the ramp terrace

the spine bridge

the park loop*

summary of comments on vision + precedent boards- public meeting #2

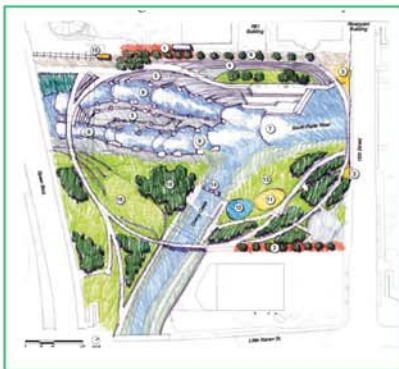
- Don't make too much focus on kayak course. Not enough R.O.I. on a daily basis vs everyday park use.
- I love the children's splash pool
- Too little. Needs more action.

- GO BIG OR GO HOME. This is the birthplace of Denver. Do it right! NOT CHEAP.
- *second that motion.
- *third that motion.
- Kayak is only one component of park, but seems to be getting lions share of funds.

- *agreed.
- Dog days (or hours) Don't ignore fact that dogs/per capita in Denver is highest and leash laws suck.
- *agreed.
- Prefer curved bridges to the straight angular feel of this plan.

- This scheme limits the latent and existing potential of this place.
- Having the splash pool removed from the river sends the message that the river is not fit for interaction. The splash pool needs to use river water and be part of the river experience.

- I think having a playsplash area on top of the hill area would be dangerous to children because that is a high traffic area.
- Using wetlands as a way to improve water quality is a perfect opportunity to show how we can work with nature to improve health and safety instead of a man made structure.

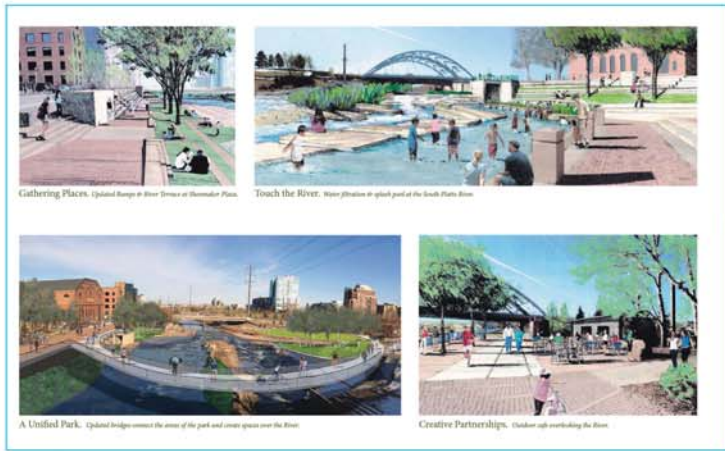
- Need more seating by the River. I like the steps leading to the river with green spaces, trees incorporated.
- I like the café/restaurant.
- Love the café area.

- I like the children's play areas in both the loop and the spine.
- I like the working bike path on SE corner away from the edge and lower lawn to river. <- another person's agreed with this comment.

- I like the idea that the bridge is also for viewing.
- Need to address how this park relates to the area immediately north and south of it.
- I like two waterways as depicted in this option.

- The park loop is small-maybe add another play and water park on the other side.
- Like #3 pedestrian bridge @ 15th.
- Is there really enough room for a competition kayak course without jeopardizing the children's daily play?

- The Park loop-love the idea of double runs-one easier, one more challenging and freestyle feature at the bottom.
- I like the double kayak course.
- Walls on Cherry Creek? Remove...Scale them down as they get closer to the Platte

- Would like to see 11, 12, and 13 more thought through/concept designed.
- Use lighting as a design element.
- I like the expanded outdoor "café" and pushed back trolley to creek. More room.

- I like removing the SW Wall (#10) in this design and (#9) in the spine design.
- I love the circular bridge design.
- I am concerned about the safety for the tubers (NOT questioning conflict of use-just safety).

- Verify that 15th street bridge is NOT going to be redone. If it is, needs to be coordinated.
- Allow bikes only on 15th Street Bridge. No bikes in the Confluence Park proper.

- Can the Kayak course be moved 100' upstream to provide more space for activity below?
- I like the circular paths. Would 5, 11, 12, 13 be flooded when the water rises?

- No reference to the birthplace of Denver? Utilize the opportunities for learning historical significance-Make a statement with it.
- Bike racks? More bathrooms? Amenities year round-not only summer. Make pedestrian/bike bridge over South Platte wider.

- Love the circular curved bridge that eliminates some of the sharp edges. I feel the architecture should reflect the pattern of the river.

vision

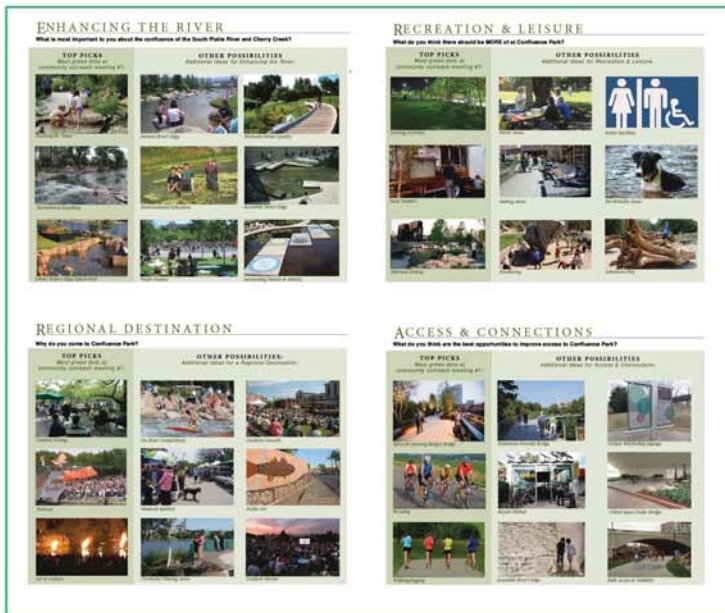
- I think Confluence is a perfect opportunity to incorporate sculpture, murals, local art to showcase Denver's culture particularly its diversity and connection to nature.

- Bridge wide enough to have thru traffic as well as small tables and chairs. Bridge may be a cool interpretive opportunity with some sort of art/signage that tells the story of the river.

- I like the removal of current ramps. Replacement with walkways that replace ramps.
- Is splash pool kid/family and pet friendly?? Are dogs prohibited?

- Lighting could also be used to draw people.
- I like the splash pool area vs. everyone in the water all over the place. Right now on a weekend it looks a bit "ghetto".

- Policies for pets need to be developed.
- Lighting in river like done in Korea?
- Bleacher steps at Shoemaker plaza are great.
- Water filtration splash pool is a great idea. Wonderful image.

- Outdoor cafe is a must.
- I see a real problem with the city maintain turf areas to provide long term enjoyment. Should sod areas be replaced with tables, chairs, umbrellas and trees??
